Beech C90, Flap Rib and Bearing Damage, ATA 5753

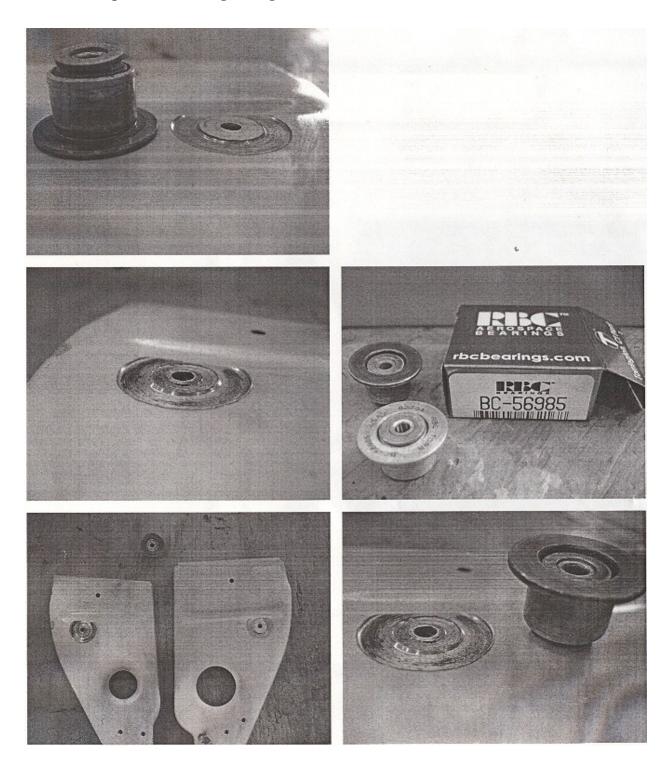
A mechanic described a flap problem on this Raytheon King Air. The left flap's aft roller bearings have very little side clearance between the bearing and the flap's rib. As the bearing wears, the side play increases to the point where the bearing flange contacts the rib.

Raytheon has not provided any chafe protection on this side of the bearing; therefore, the bearing begins to cut into the rib as it rolls fore and aft.

A small, thin Teflon washer would prevent contact and allow the bearing wear to be detected before damage occurs (RBC Bearing P/N: BC-56985).
